For: DATA COMMUNICATION METHOD, ELECTRONIC APPARATUS,
AND PHYSICAL-LAYER-CONTROL INTEGRATED CIRCUIT

PRELIMINARY AMENDMENT

REQUEST FOR APPROVAL OF DRAWING CHANGES

FIG. 6

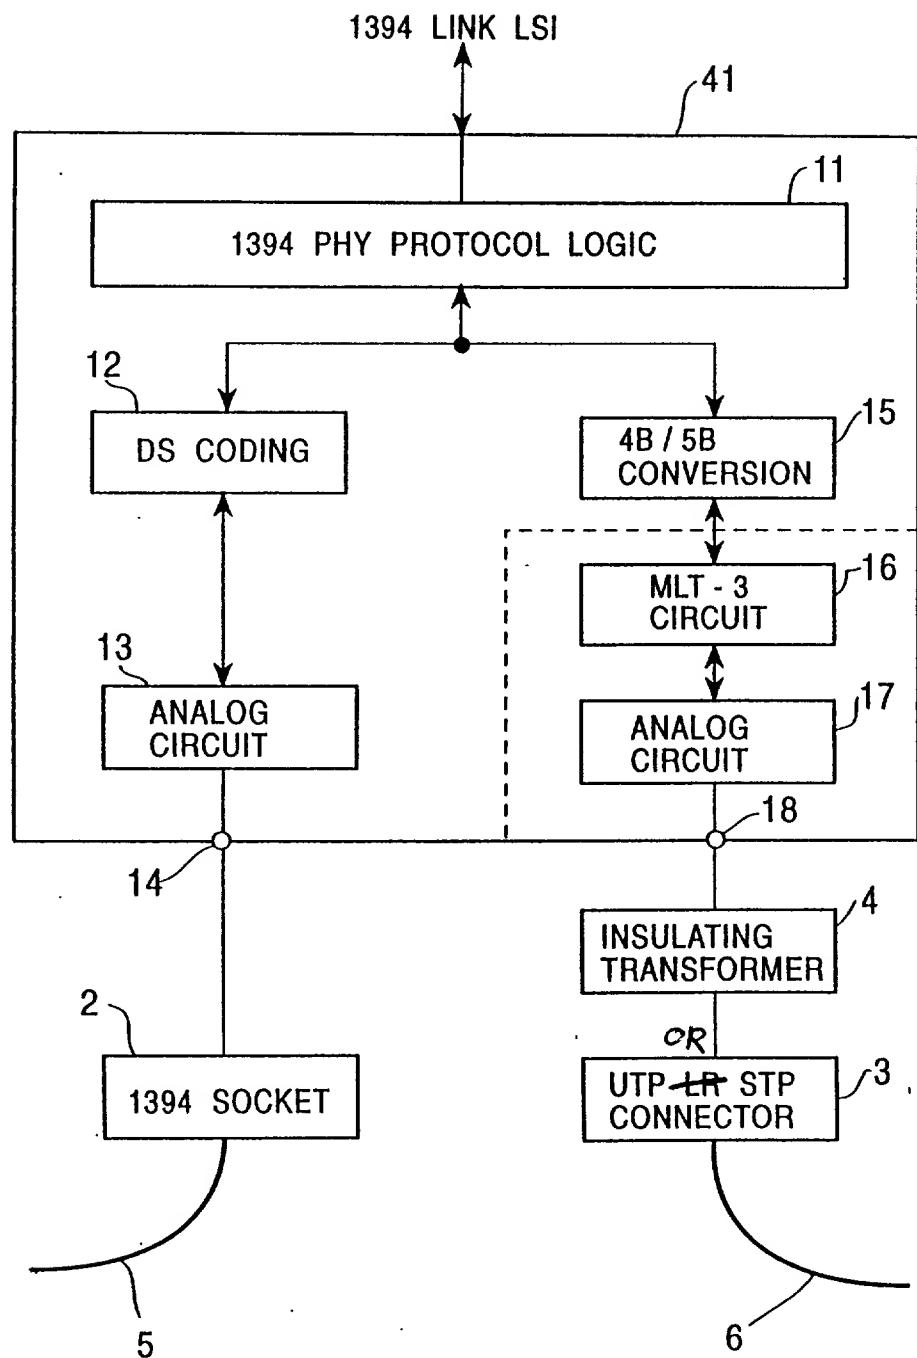
FIG. 6: In block 3, change "LR" to --OR--;
